**A G E N D A**  
**JAMES CITY COUNTY DEVELOPMENT REVIEW COMMITTEE**  
**REGULAR MEETING**  
**Building A Large Conference Room**  
**101 Mounts Bay Road, Williamsburg, VA 23185**  
**June 17, 2020**  
**4:00 PM**

## SITE PLAN-20-0015. Virginia Health Services, Colonial Heritage

Applicant:	Mr. Ryan Kiss
Land Owner:	Virginia Health Services, Inc.
Proposal:	New construction of a +/-160,670-square-foot assisted living facility on one of the commercial parcels of the Colonial Heritage Master Plan.
Location:	6799 Richmond Road
Tax Map/Parcel No.:	2430100032
Project Acreage:	±23.35 acres
Current Zoning:	MU, Mixed Use with Proffers
Comprehensive Plan:	Mixed Use
Primary Service Area:	Inside
Staff Contact:	Tori Haynes, Senior Planner

**TO:** TORI HAYNES, PLANNER  
**FROM:** JOSE L RIBEIRO, SENIOR PLANNER II  
**SUBJECT:** SP-20-0015. VHS WILLIAMSBURG  
**DATE:** 4/6/2020

5 SKILLED NURSING - ELEVATION 5  
A401 1/8" = 1'-0"

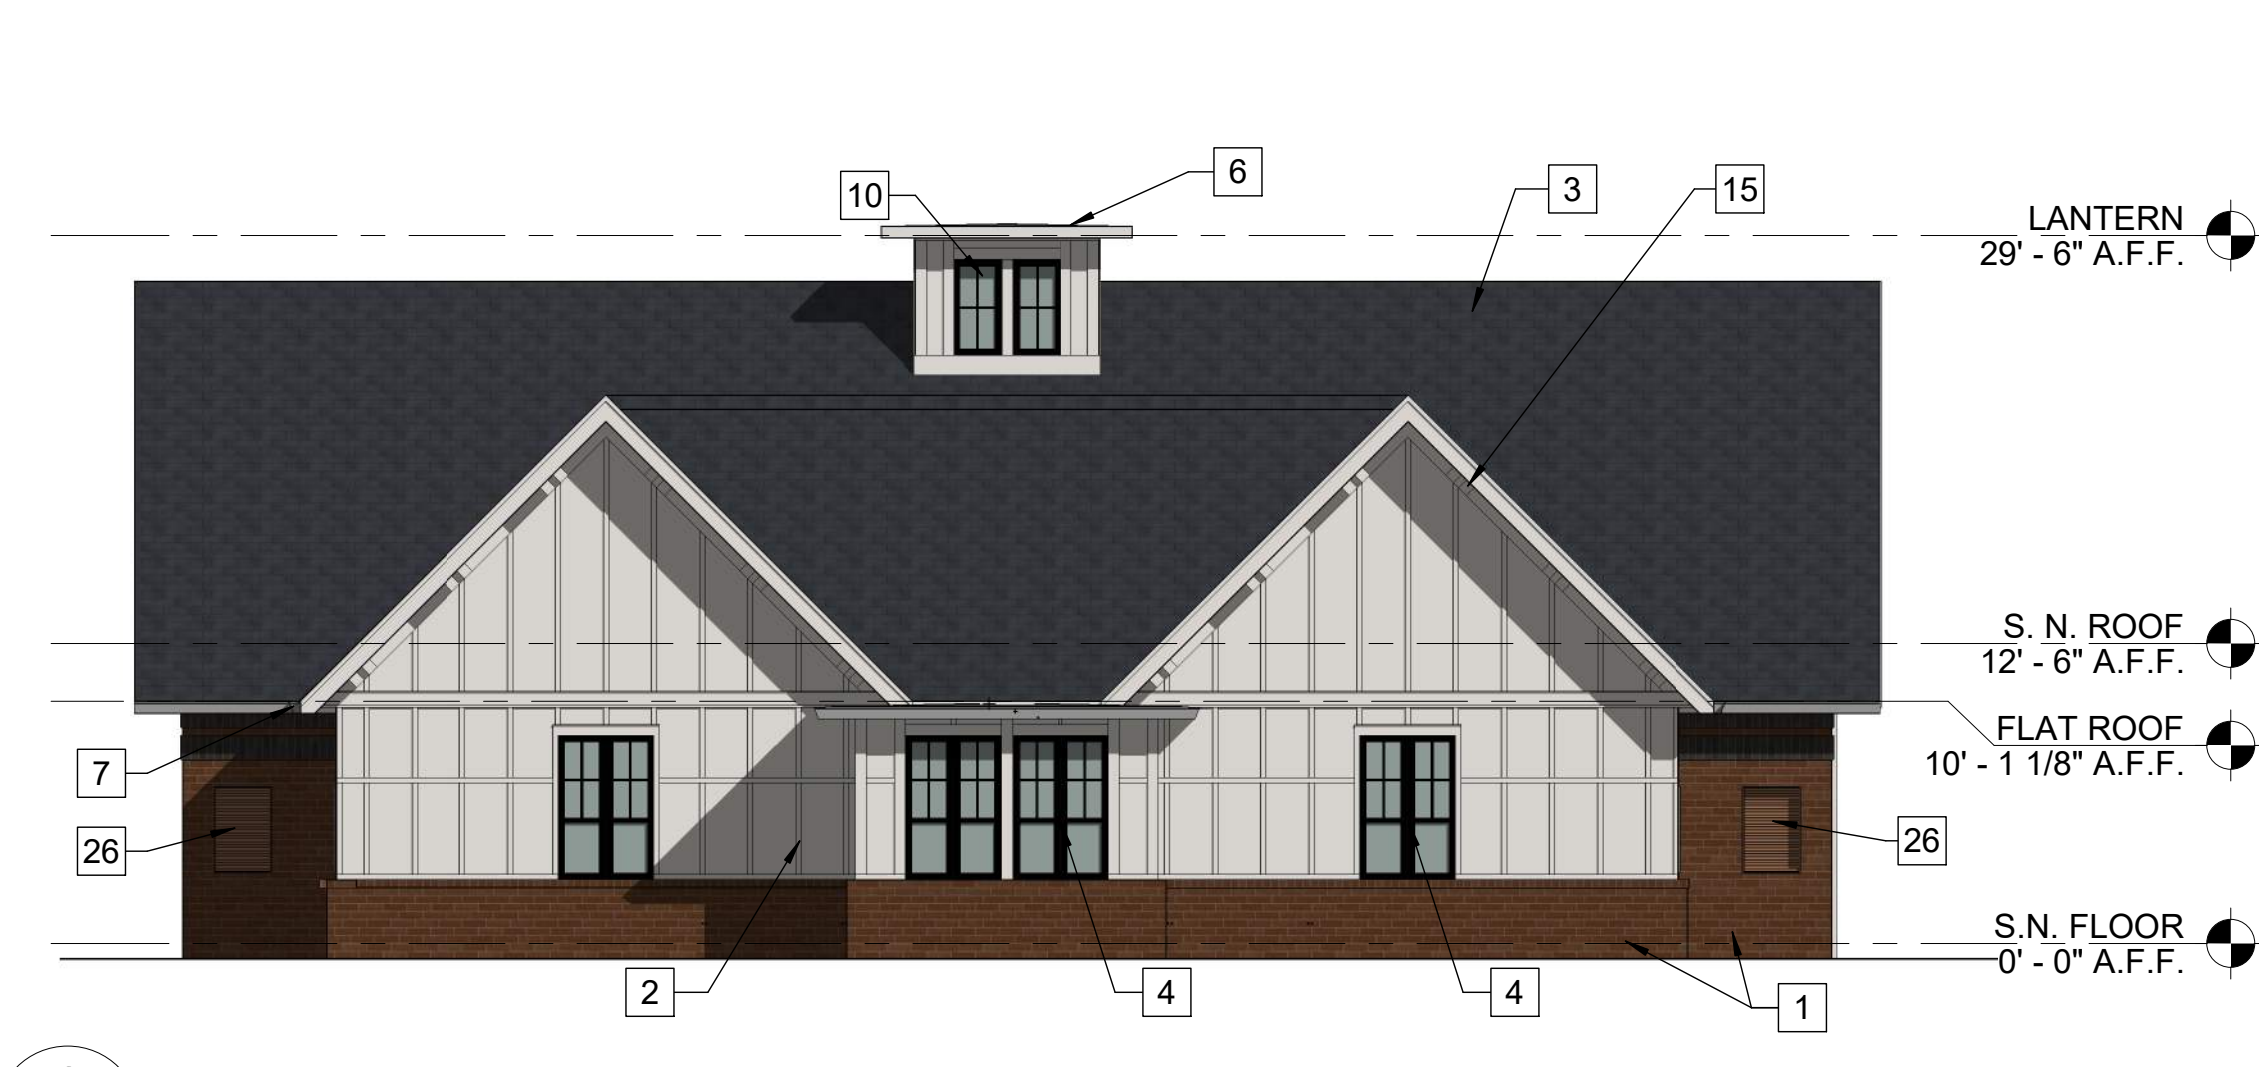
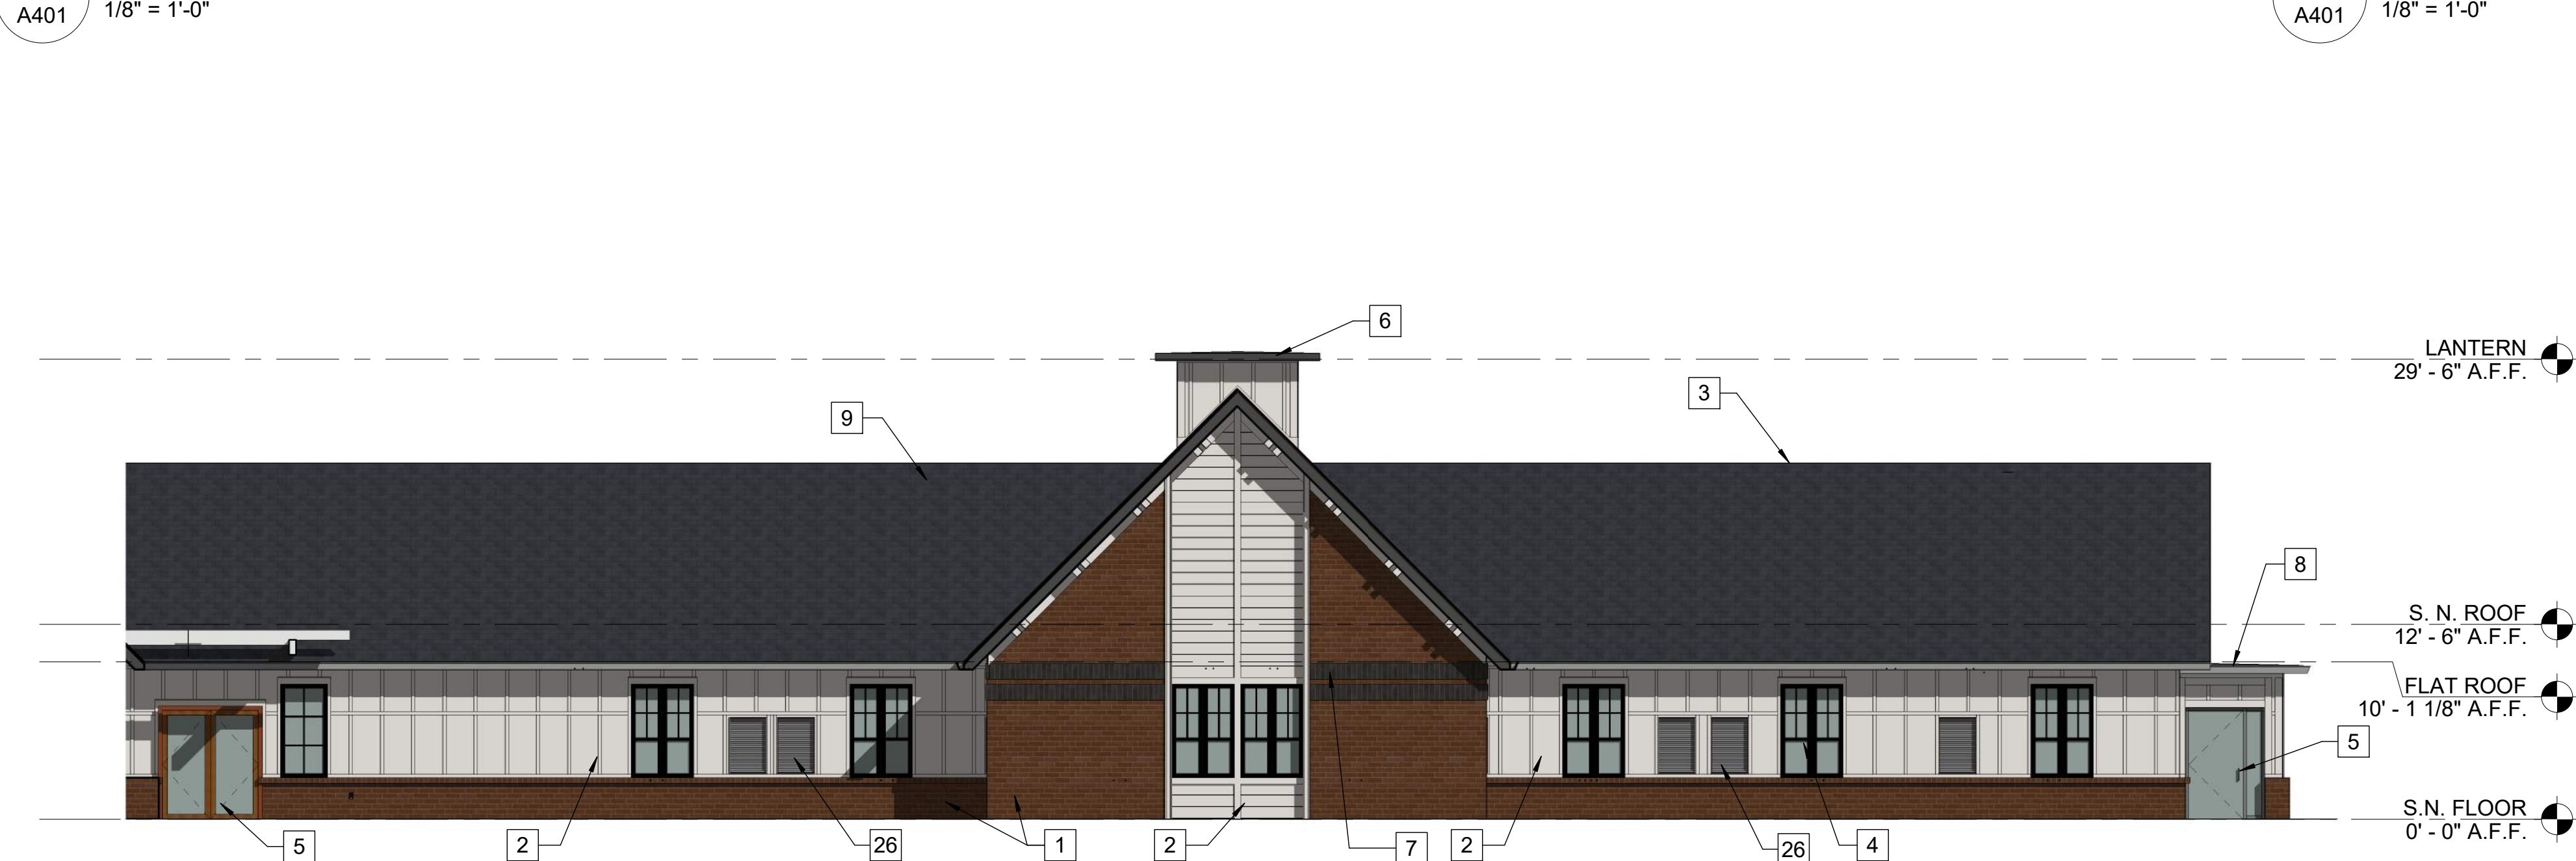
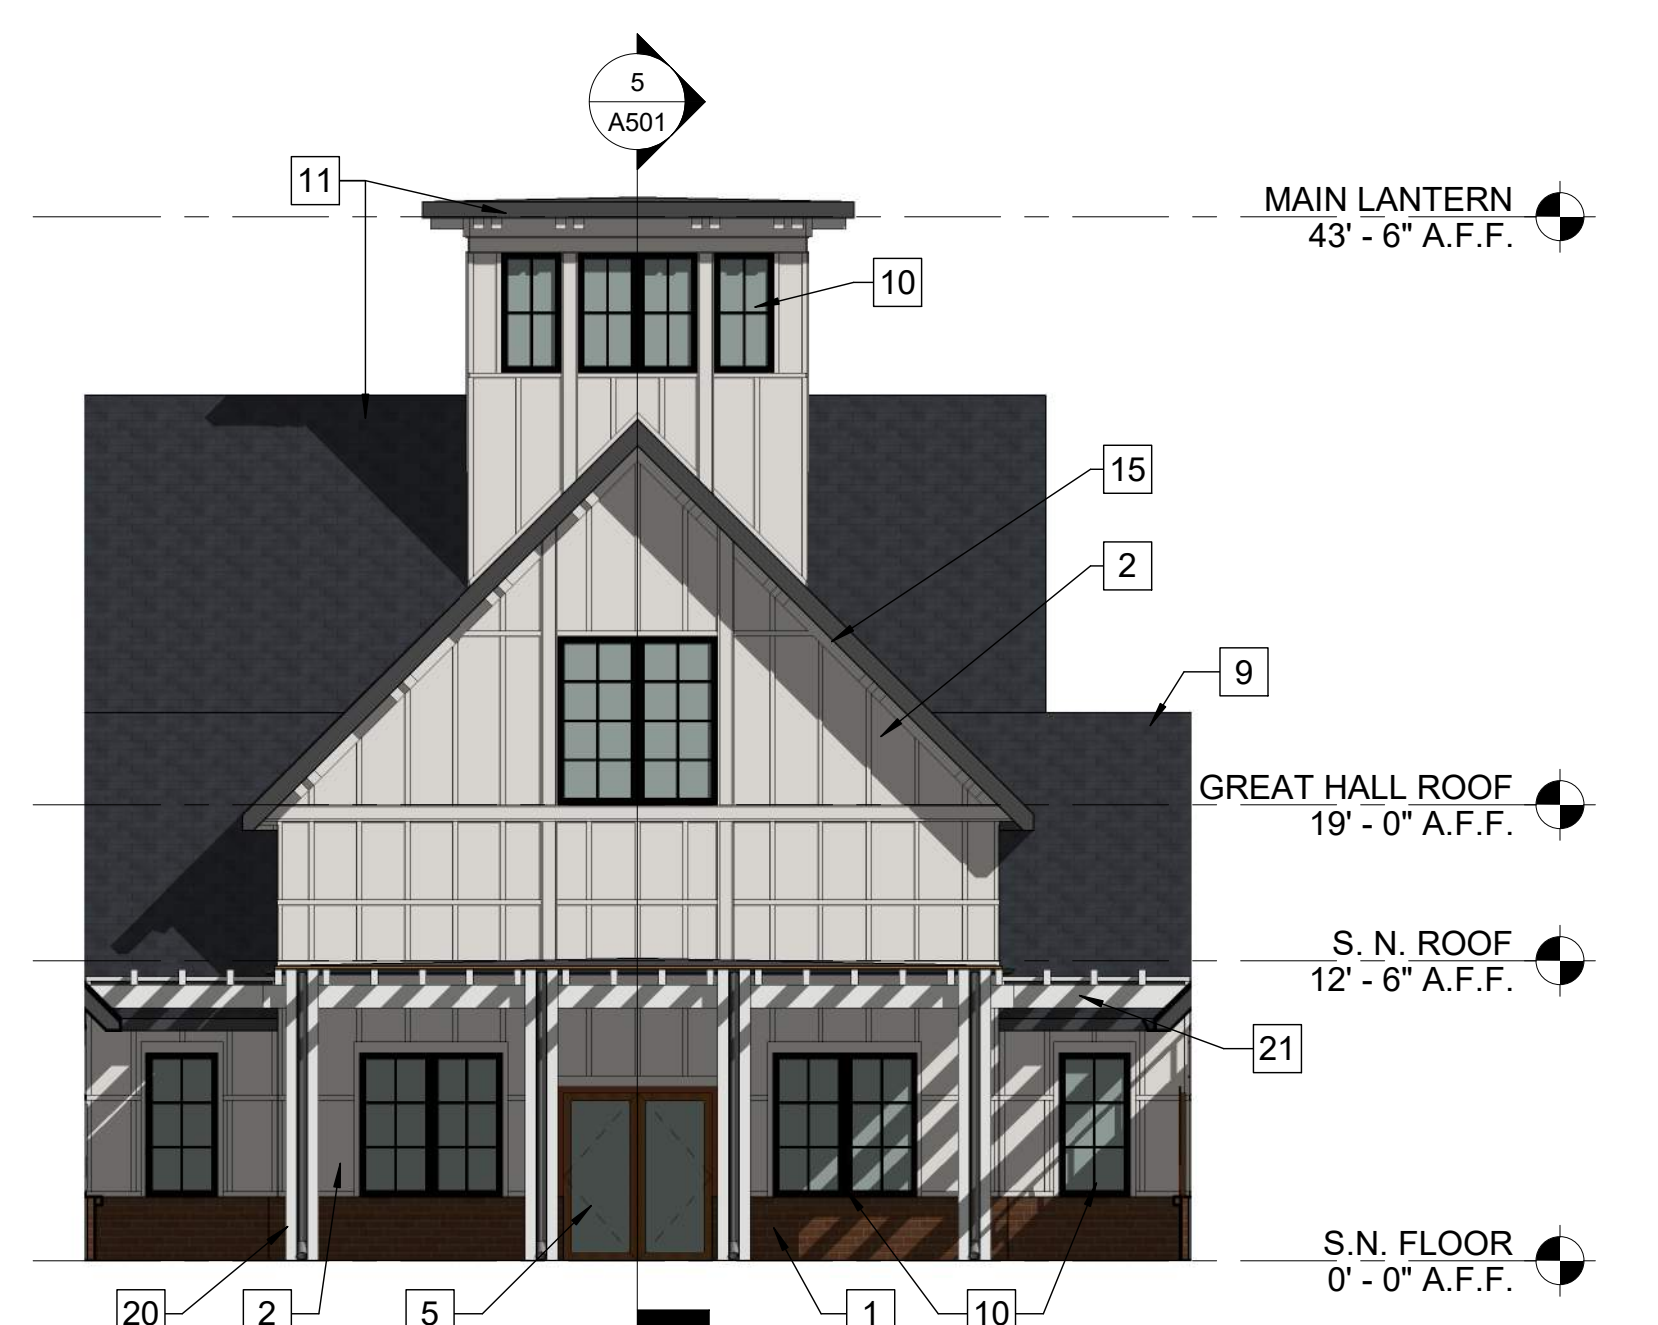
1. Staff finds that the 12/12 roof pitch on the single-story sections as shown in the proposed elevations is not consistent with the approved design guidelines, which show a less severe pitch that is more proportionate to the lower height of a single-story structure.

Staff finds that the elevation design of the one-story sections are generally consistent with these guidelines, with the exception of the roof, which appears to be at a steeper pitch than what is presented in the approved design guidelines (see Attachment No. 4, Page 8, Figure 1.21). While the pitch is not specifically called out in the design guidelines, when comparing the proposed single-story elevations to Figure 1.21, staff determined that the proposed 12/12 roof pitch creates a more severe visual impact relative to the lower height of the single-story sections. Staff did not have this concern on the multistory sections.

Staff recommends that the DRC approve the proposed building elevations, subject to a revised roof design on the single-story sections to achieve more visual balance and to be more consistent with the approved design guidelines, as determined by the Planning Director.

Staff recommends that the DRC recommend approval of the proposed building elevations, subject to a revised roof design on the single-story sections to achieve more visual balance and to be more consistent with the approved design guidelines, as determined by the Planning Director.

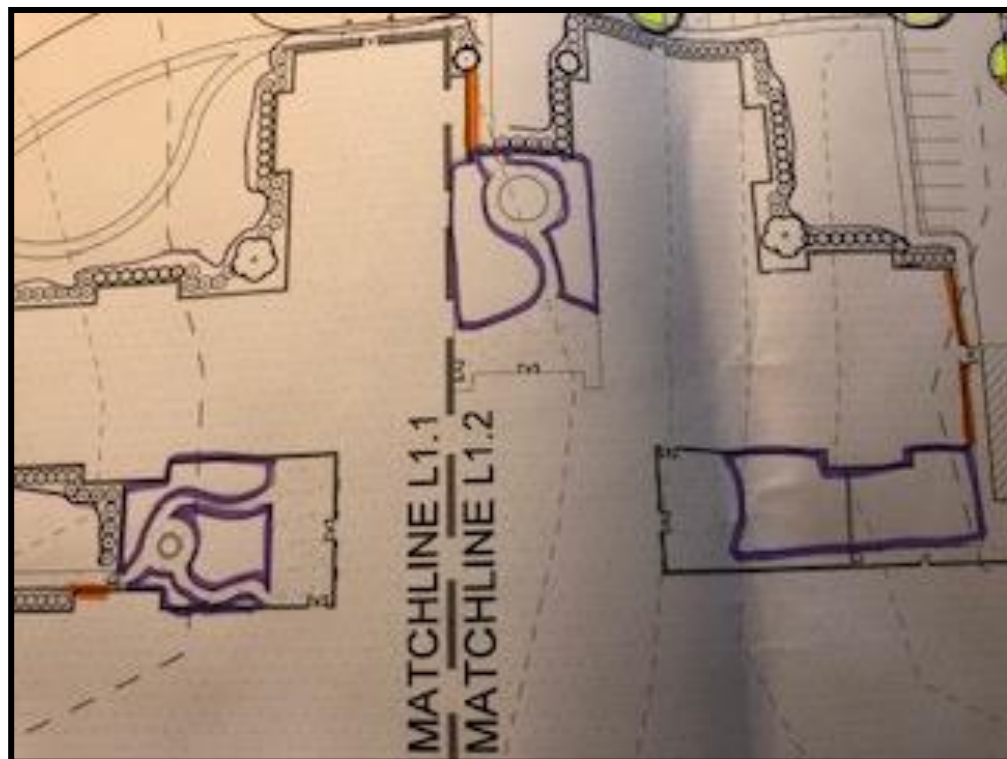
1. The picture below (from Sheet No. L1.0 of site plan SP-20-0015) shows the footprint of the proposed building.
  - a. What is the total perimeter of the building?
  - b. Areas highlighted in orange represents breaks in landscaped areas adjacent to the building. Areas highlighted in purple represent areas also adjacent to the building and not landscaped. On a brief narrative please indicate the reason why these areas are not being landscaped in accordance with Section 24-97 of the Zoning Ordinance.
